ADDENDUM #1

Northern Moraine Wastewater Reclamation District

Sludge Drying Bed Cover

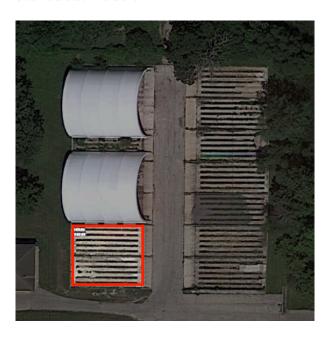
3. Please confirm which of the beds you are looking to cover based on the photo below.

See red outline below:
